This application is a continuation associated with prior application Serial No. 08/637,894 filed April 25, 1996. The application was abandoned and a Petition to Revive was filed on May 1, 1999. This Petition was apparently granted since a filing receipt and two Office Actions were issued for this case, however no paperwork showing the grant of the petition has been received by the applicant. The applicant respectfully requests a copy of the paperwork showing that the Petition to Revive was granted.

It is believed that entry of the foregoing preliminary amendment will place the claims of this application in condition for allowance. Specifically, Claims 1 and 15-17 have been amended. In view of the foregoing amendments and the following argument for patentability, the applicant hereby respectfully requests entry of the amendment and allowance of the subject application.

Proposed Drawing Changes

FIG. 2

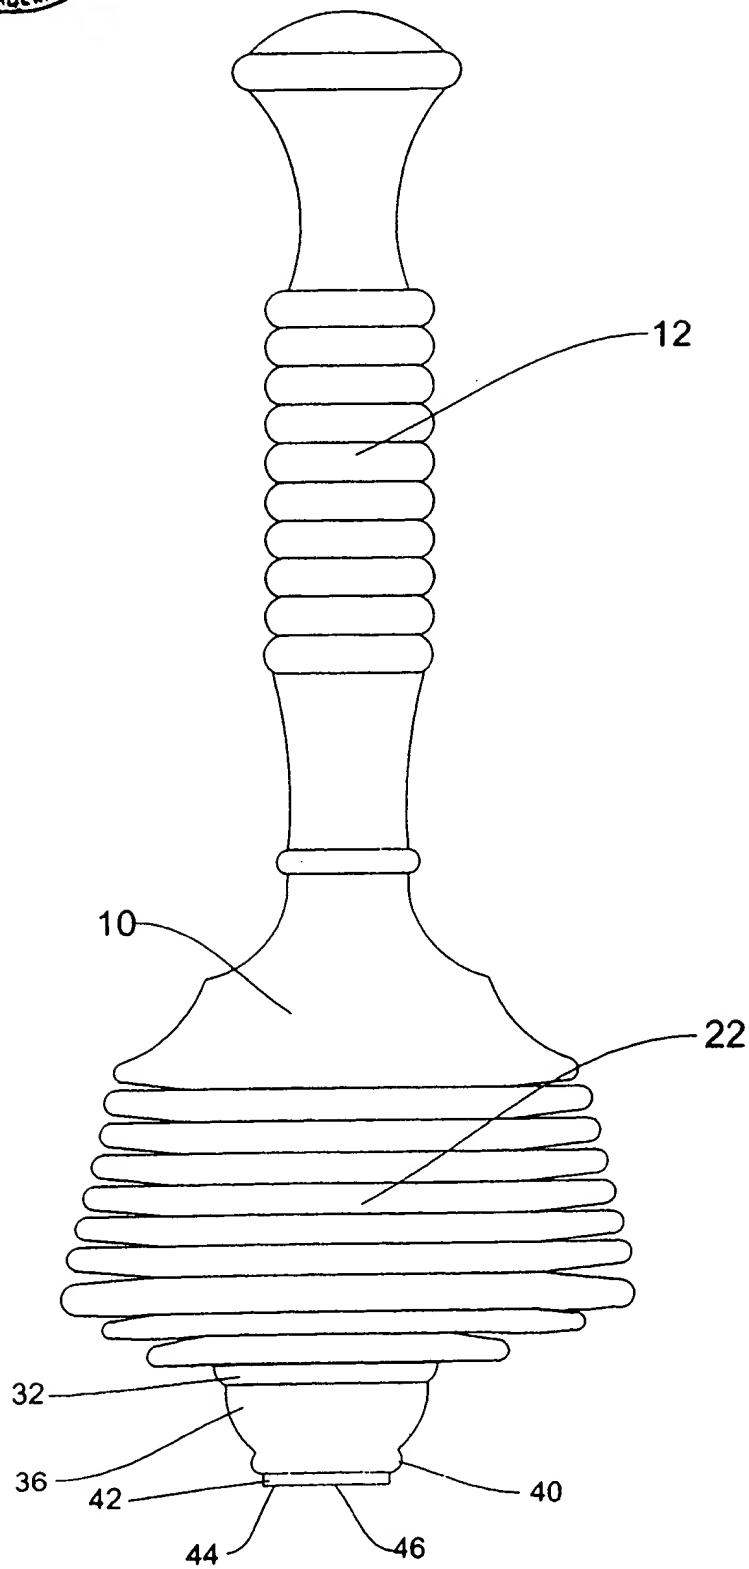
In the previous non-final Office Action the drawings were objected to because the cross-hatching is inaccurate as to the material in FIG. 2 and reference numeral 54 is missing from FIG. 5. Additionally the drawings were objected to under 37 CFR1.83(a). It was stated that the drawings must show every feature of the invention specified in the claims. The Examiner stated that the integral handle set forth in Claim 17 must be shown or the feature(s) entered from the claim(s).

In response to the previous non-final Office Action, the figures were amended and a proposed drawing change was submitted. Specifically, the applicant was not sure which cross-hatching the Examiner referred to with respect to FIG. 2, as there is no cross-hatching in FIG. 2. The applicant, however, amended some cross-hatching in FIG. 3. The applicant further amended FIG. 5 to show reference numeral 54. Additionally, the applicant added a new FIG. 4 (previously submitted as new FIG. 6), showing a plunger with an integrally formed handle. Support for this change is found in the specification on page 3, lines 20-24, which state,

FIG. 6

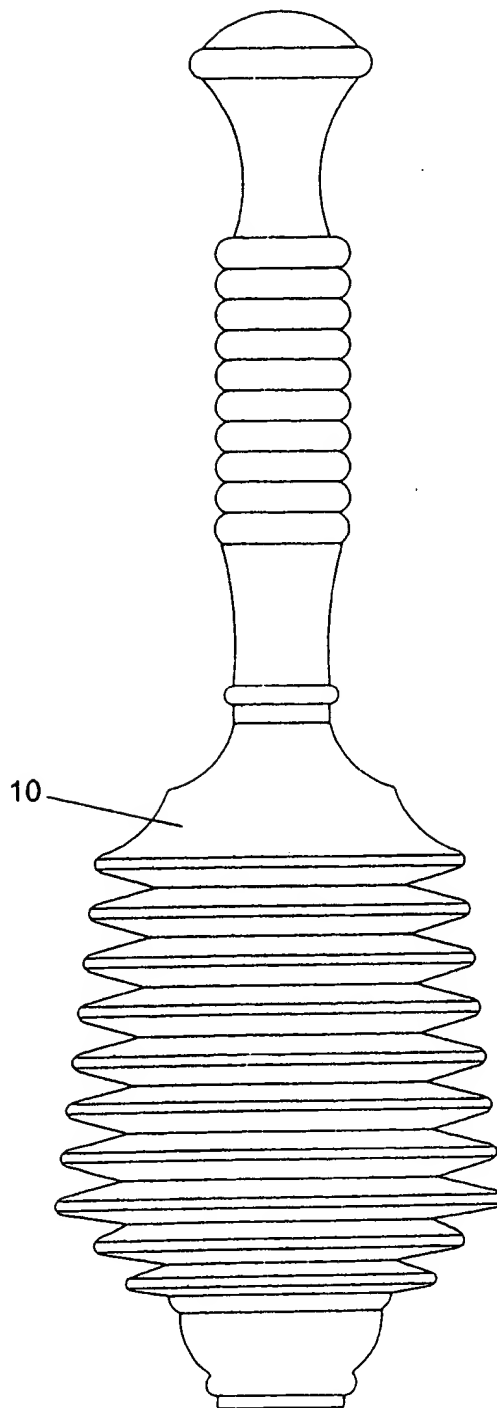
Figure 4 is a schematic side view elevation, of a preferred embodiment of the toilet and sink drain plunger of the present invention showing the plunger with an integrally formed handle.

[Alternately the entire plunger 10 can be of unitary construction, as shown in FIG. 6.] to

Alternately the entire plunger 10 can be of unitary construction, as shown in FIG. 4.

Not
Approved
10/23/02
Max
